**RFB NO. 313083 - ADDENDUM NO. 1**

**CONSTRUCTION OF EAST HIGHWAY GARAGE – SALT  
STORAGE FACILITY (BID PACKAGE A) AND  
MEDICAL EXAMINER OFFICE BUILDING (BID PACKAGE B)**

**DEPARTMENT OF PUBLIC WORKS,  
HIGHWAY & TRANSPORTATION  
3562 COUNTY HIGHWAY AB  
MCFARLAND, WISCONSIN**

4 ENLARGED CHILLER ROOM - HVAC  
M401 SCALE: 1/4\"/>

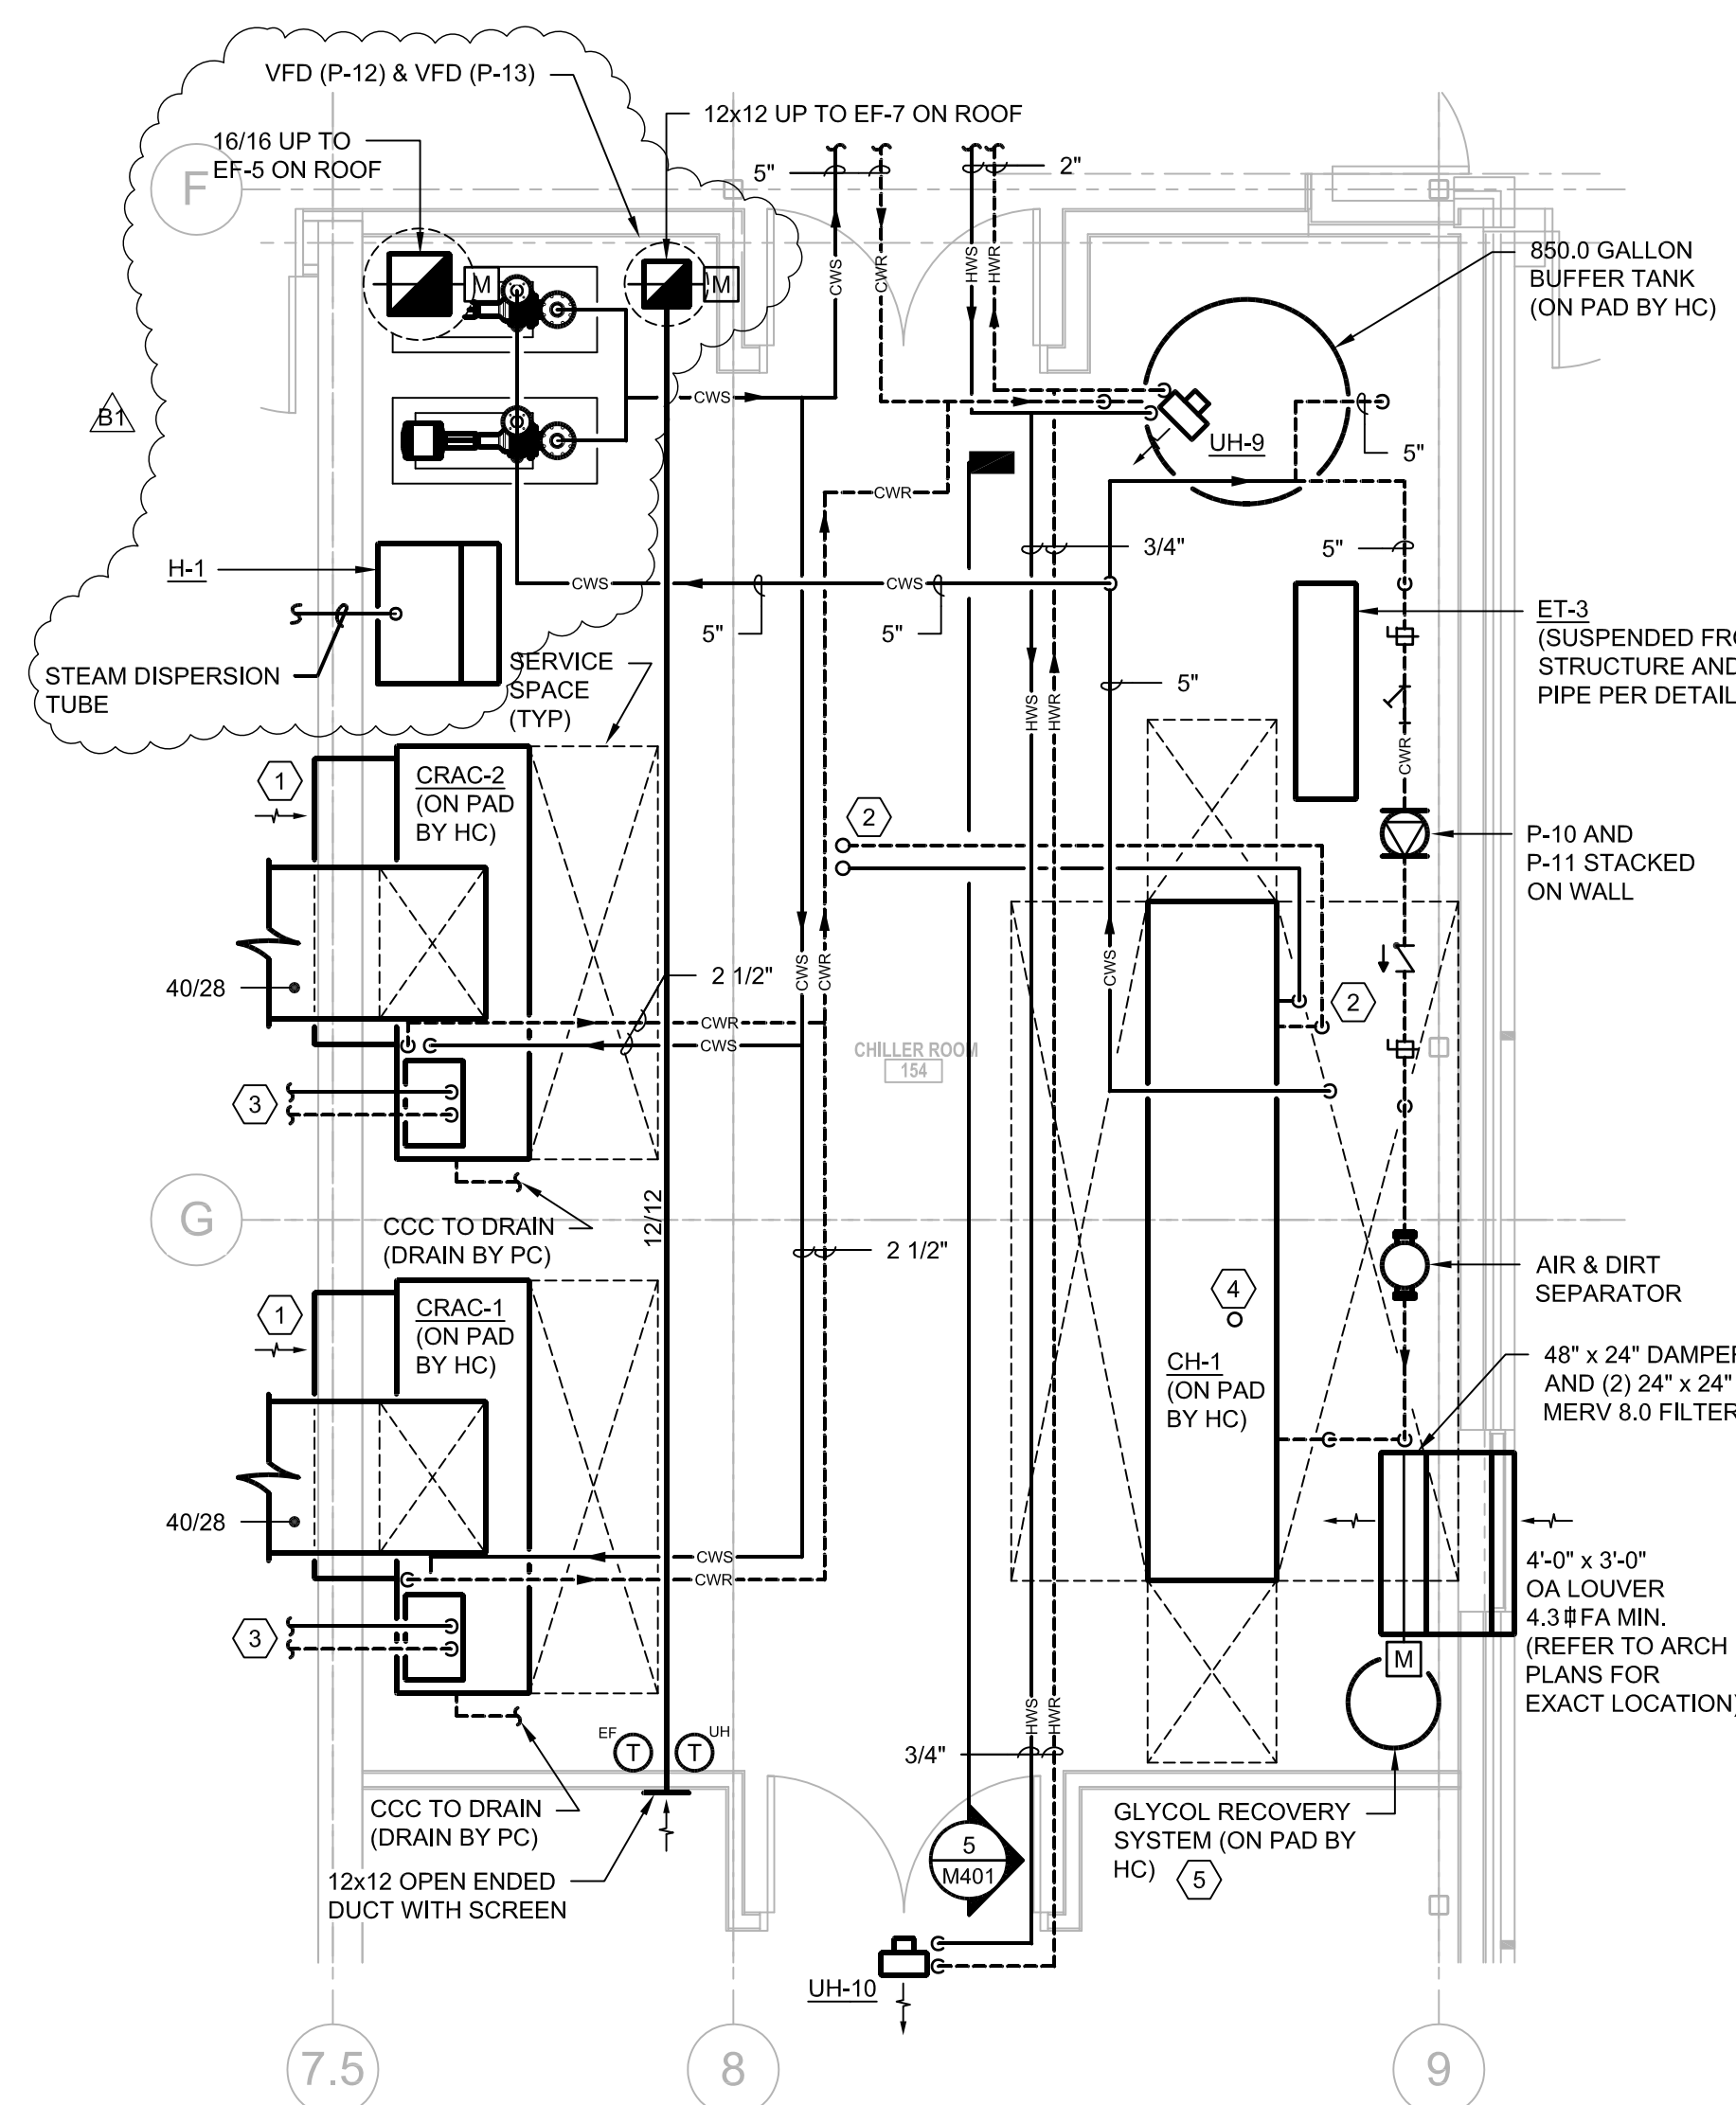
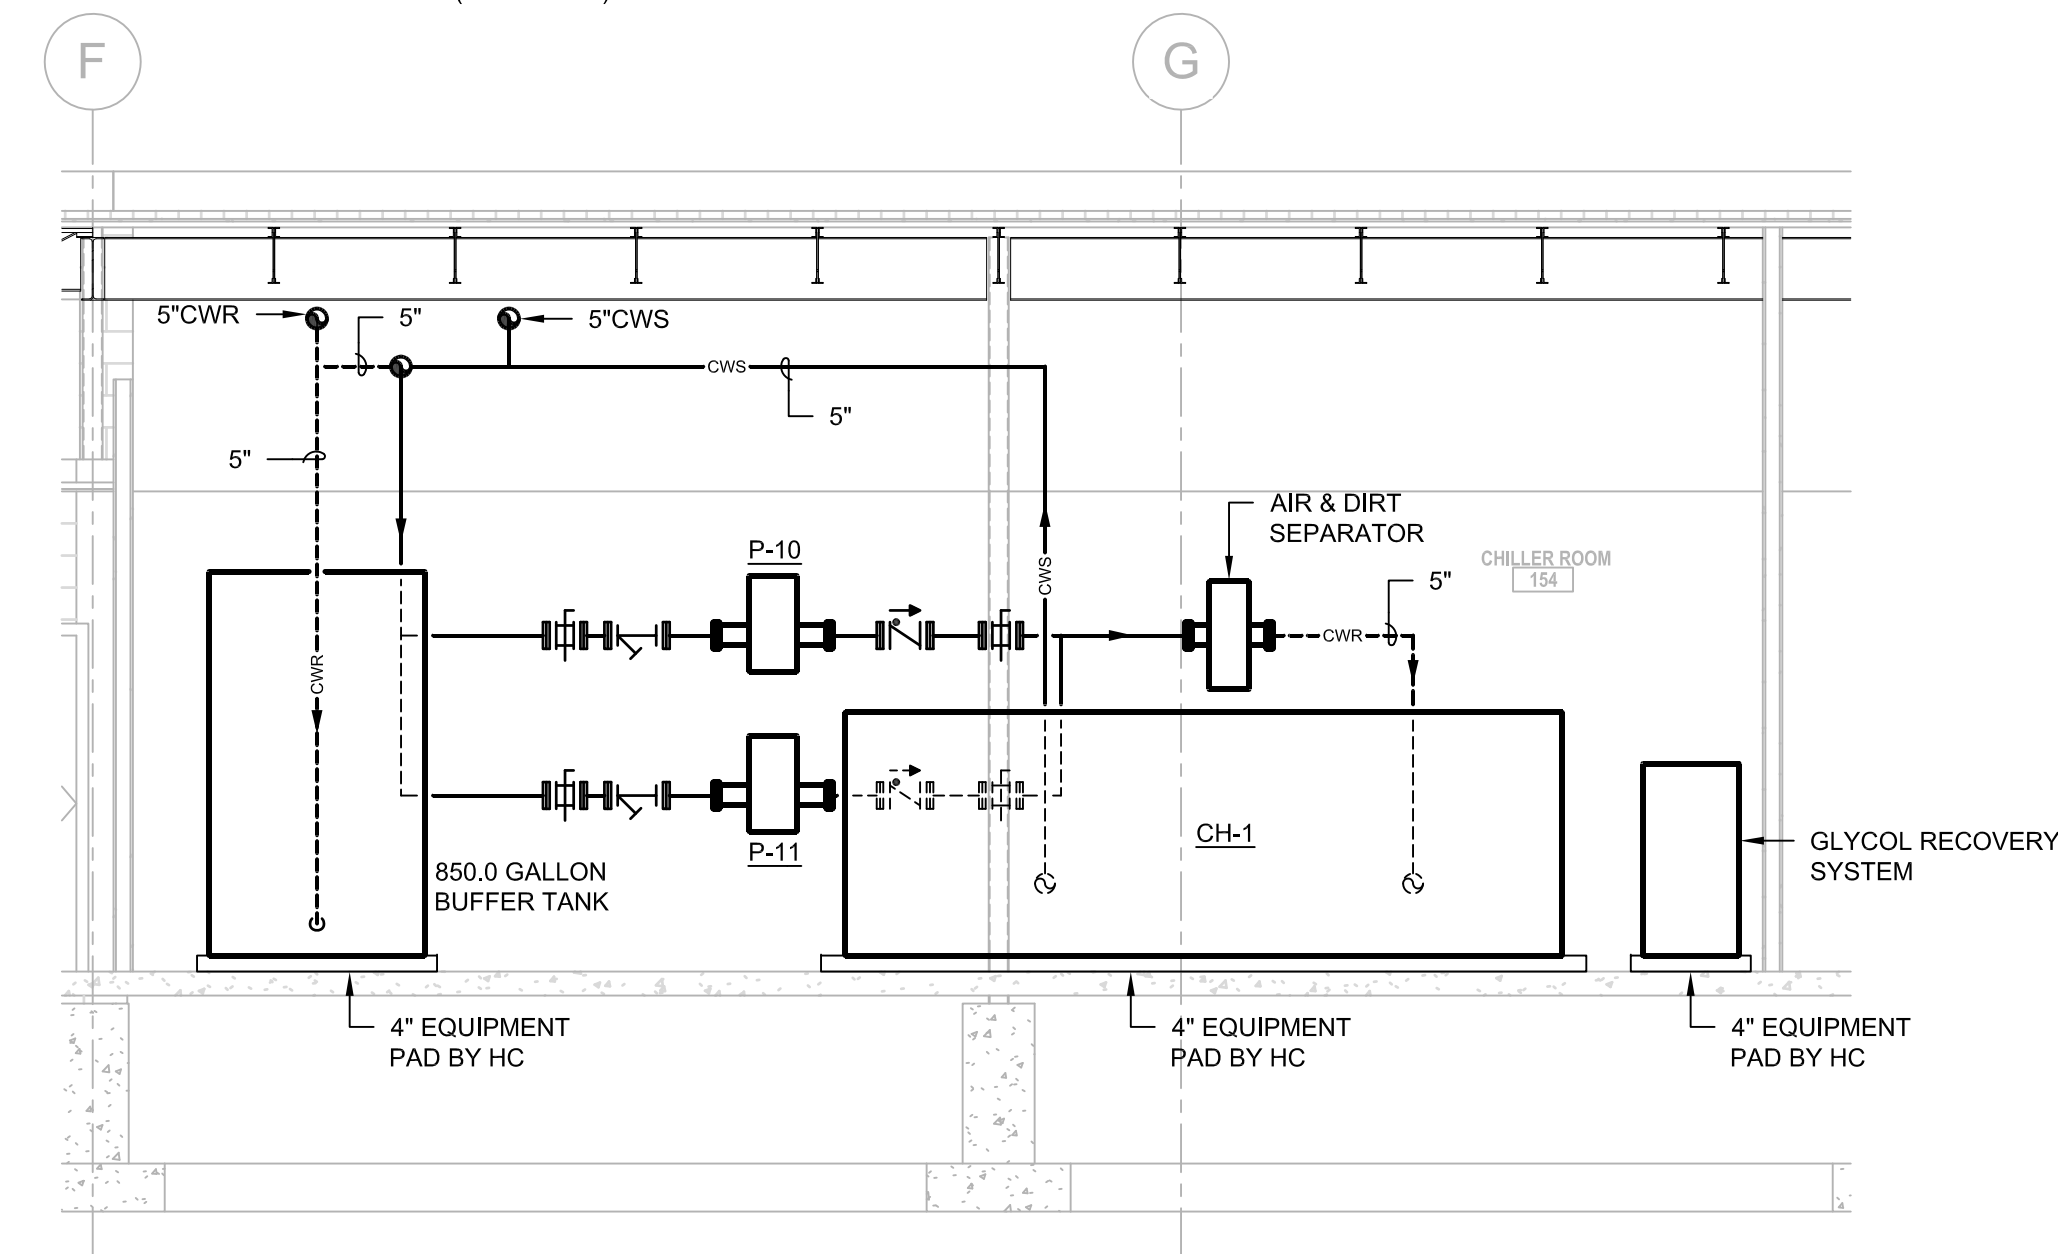
63. SHEET M201
- a. See revised drawing, M201, attached.
64. SHEET M300
- a. See revised drawing, M300, attached.
65. SHEET M401
- a. See revised drawing, M401, attached.
